TRAVEO™ T2G CYT2CL errata sheet

Marking/Step: Rev. A

32-bit single-chip microcontroller

Figure 2 CAN frame with DLC > 4

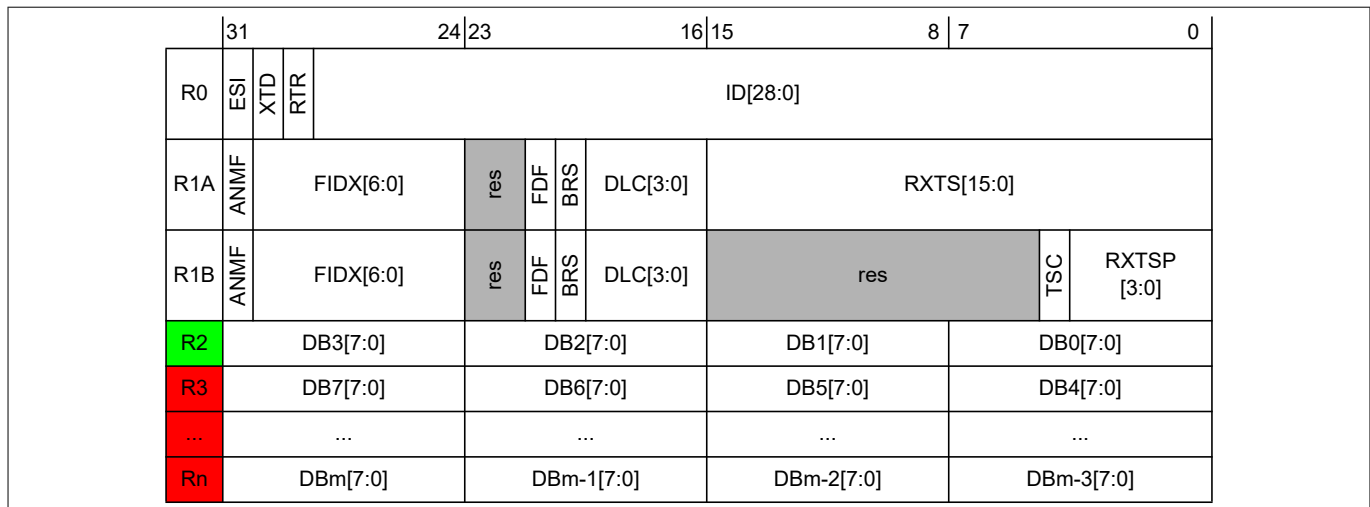
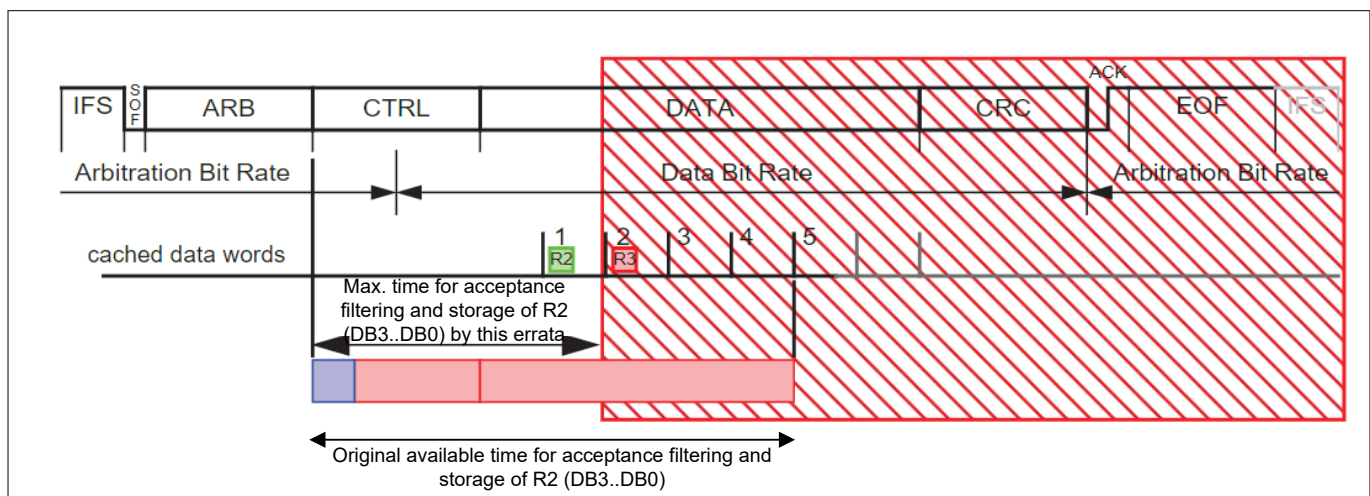
Under the following conditions a received message will have corrupted data while the received message is signaled as valid to the host.

1. The data length code (DLC) of the received Message is greater than 4 ($DLC > 4$)
2. The storage of R_i of a received message into the Message RAM (after acceptance filtering is done) has not completed before $R_{(i+1)}$ is transferred from the CAN Core into the cache of the Rx Handler (where $2 \leq i \leq 5$)
3. While condition 1 and 2 apply, a concurrent read of data word R_i from the cache and write of data word $R_{(i+1)}$ into the cache of the Rx handler happens

The data will be corrupted in a way, that in the Message RAM $R_{(i+1)}$ has the same content as R_i .

Figure 2 shows how the available time for acceptance filtering and storage is reduced.

Due to condition 3 the issue occurs only sporadically. Use an end-to-end (E2E) protection (for example, checksum or CRC covering the data field) and add it to all messages in the CAN system, to detect data corruption in received frames.
